**ADDENDUM NO. 3**

**RE: Item #3, February 18, 2026 Letting - IM 0292(93)76, PCN 092A, Minnehaha County - LSDC Overlay, Concrete Barrier, Joints, Approach Slabs, Portland Cement Pavement, Pedestrian Rail**

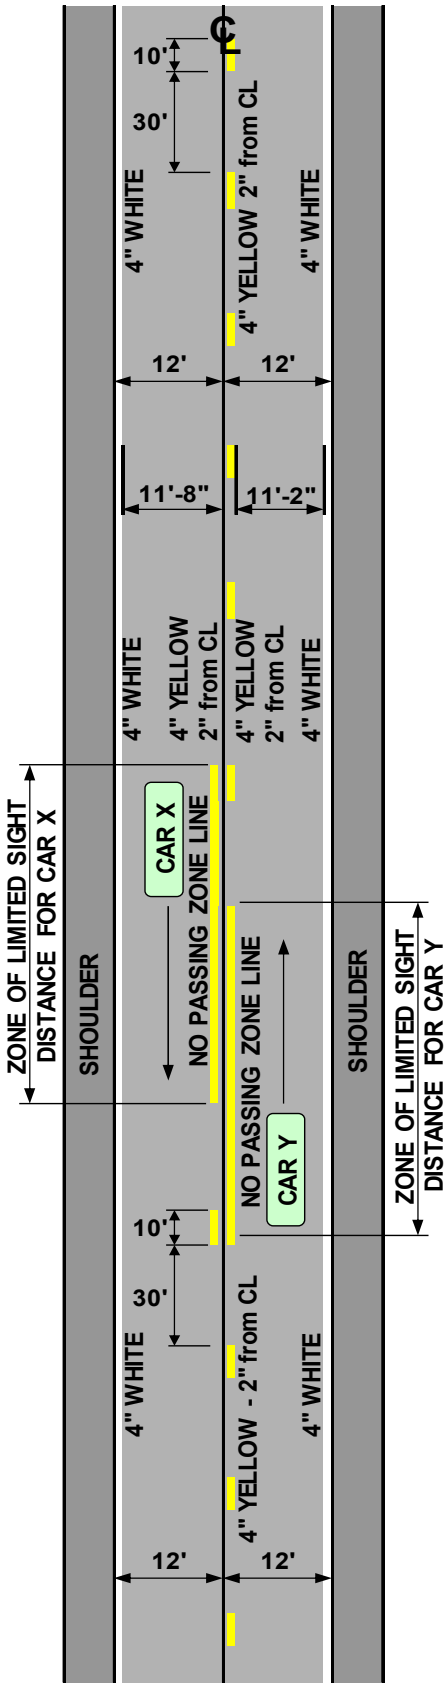
**Sheets 6 & 6A:** LANE CLOSURES, WORK ZONE SPEED REDUCTION, CONTRACTOR FURNISHED SPEED MONITORING RADAR TRAILER, CONTRACTOR FURNISHED PORTABLE CHANGEABLE MESSAGE SIGN & TEMPORARY PAVEMENT MARKERS notes were added.  
PREFORMED THERMOPLASTIC PAVEMENT MARKING notes were moved to Sheet 6A.

PLATE NUMBER  
634.63

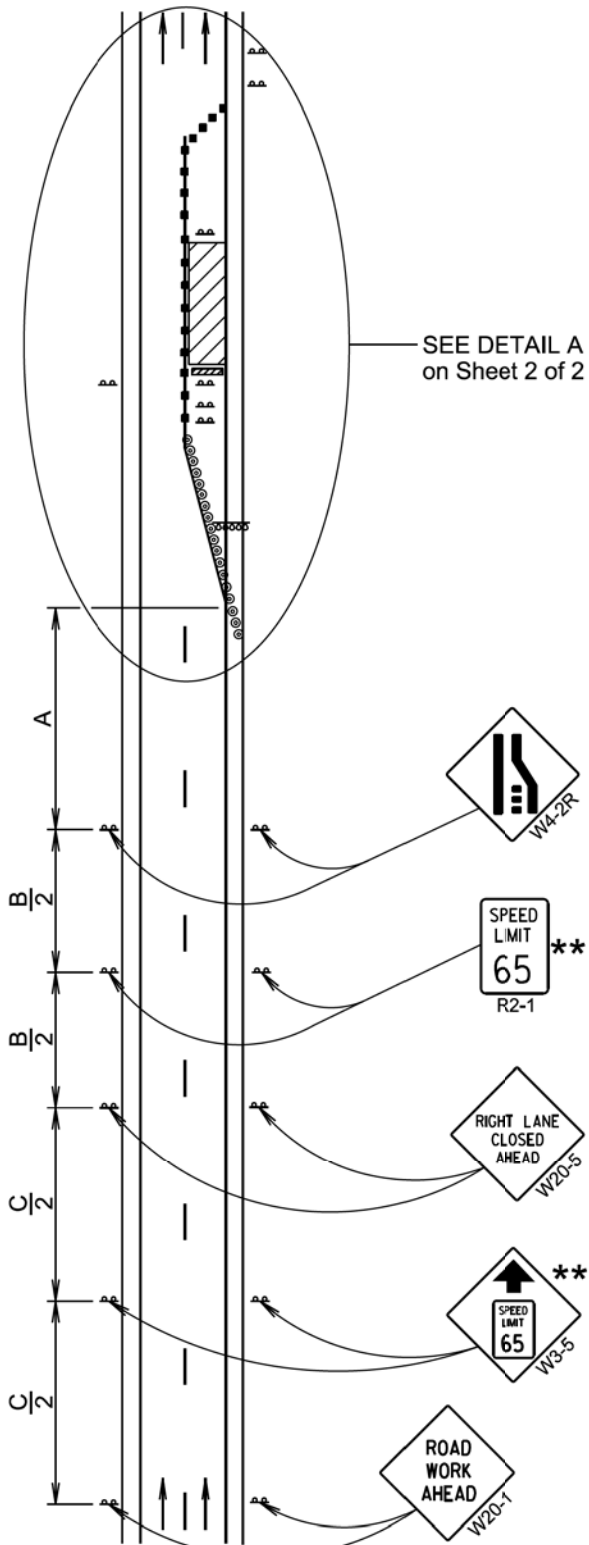
**Sheet 11:** STANDARD PLATE 634.63 was added and STANDARD PLATE 634.99 was moved to Sheet 11A.
